Access Compliance Report

Public Rights-of-Way

(Pedestrian Signals)

Intersection ID: N/A	Main Street:	Cross Street: N/A	Location: N/A
ADA ID: F1D720689308	Signal Type: One Push Button-Non APS	Overall Compliance: No	Severity Score: BTN 1: N/A BTN 2: N/A No BTN: N/A
Codes/Mitigation Info/Possible Solution		Field Measurements/Component Compliance

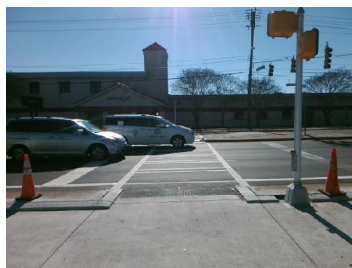
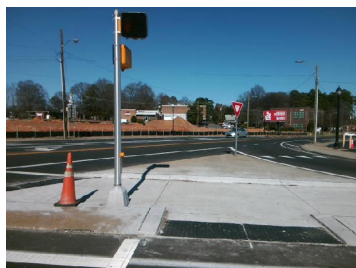
PROW/ADA: R404.2, R404.3, R404.7.2

N/A	B 1 FWD Approach Width (in)	N/A	N/A	B 2 FWD Approach Width (in)	N/A
N/A	B 1 FWD Approach Obstruction?	Yes	N/A	B 2 FWD Approach Obstruction?	N/A
N/A	B 1 FWD Approach Obstruction Dist (in)	3.0	N/A	B 2 FWD Approach ObstructionDist (in)	N/A
N/A	B 1 PARA Approach?	Yes	N/A	B 2 PARA Approach?	N/A
N/A	B 1 PARA Approach Constrained?	Yes	N/A	B 2 PARA Approach Constrained?	N/A
Yes	B 1 PARA Approach Reach (in)	4.0	N/A	B 2 PARA Approach Reach (in)	N/A
No	B 1 PARA Approach Width (in)	48.0	N/A	B 2 PARA Approach Width (in)	N/A
N/A	B 1 PARA Approach Obstruction?	Yes	N/A	B 2 PARA Approach Obstruction?	N/A
N/A	B 1 PARA Approach Obstruction Dist (in)	4.0	N/A	B 2 PARA Approach ObstructionDist (in)	N/A
No	B 1 Clear Floor Space Slope (%)	2.2	N/A	B 2 Clear Floor Space Slope (%)	N/A
Yes	B 1 Clear Floor Space XSlope (%)	0.1	N/A	B 2 Clear Floor Space XSlope (%)	N/A
N/A	B 1 PAR Slope (%)	N/A	N/A	B 2 PAR Slope (%)	N/A
Yes	B 1 Height (in)	36.0	N/A	B 2 Height (in)	N/A

Possible Solutions: Remove and Replace Clear Space.
